JRPP No.	2013STH008
DA No.	DA-2013/666
Proposal	AMENDED - The construction of an eighteen storey building over three levels of basement comprising ground floor retail with 3 levels of commercial above with 12 levels of residential, a landscaped podium with a total of 79 apartments.
Property	14-18 Auburn Street, Wollongong
Applicant	Baker Kavanagh Architects
Responsible Team	City Planning City Centre Team

Purpose of this Report

This addendum report provides a summary and assessment of the revised design received after the submission of Councils report to the JRPP for the 1 December 2014 meeting.

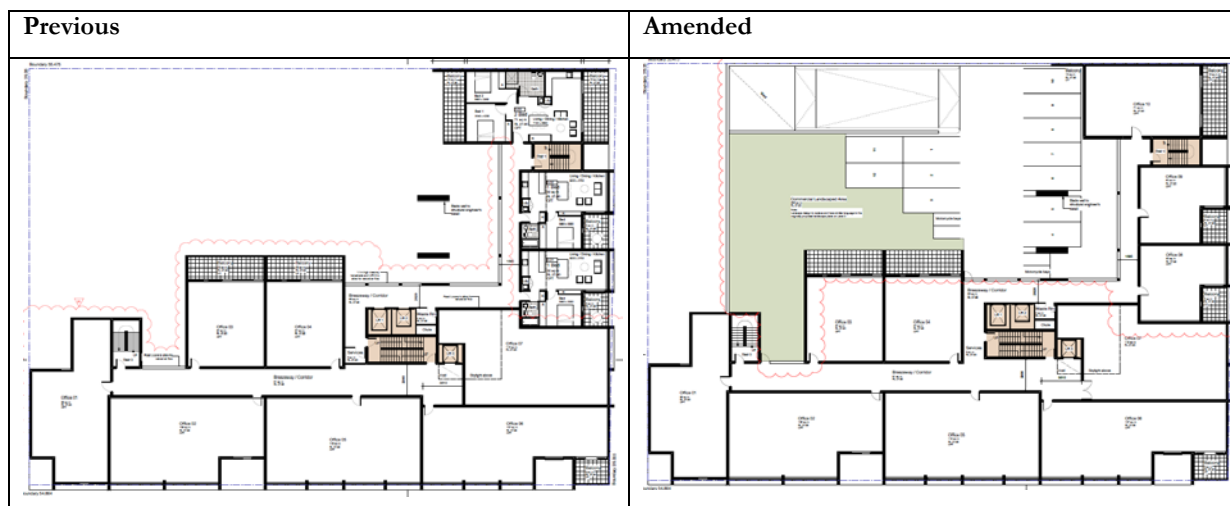
Increase in commercial floor area

The ground floor to the third storey provided wholly for retail and commercial space with the fourth floor allowing for a mix of commercial and residential accommodation. The fourth floor has now been amended to incorporate commercial only resulting in the reduction of 3 residential apartments.

The floor plans below show a comparison of the change

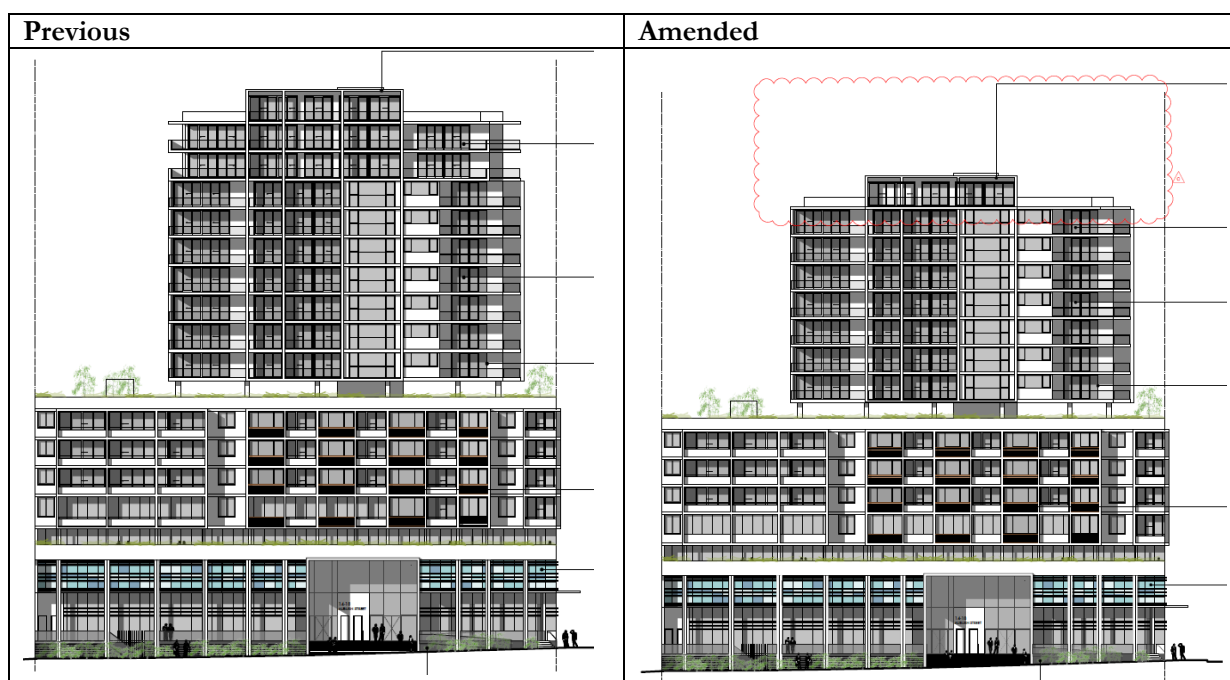
Reduction of two levels

The building has been reduced in height with the removal of floor 16 and 17. Reducing the height of the building from 18 stories to 16 stories. Resulting in a reduction of 6 residential apartments.

The elevation plans below show a comparison of the change.
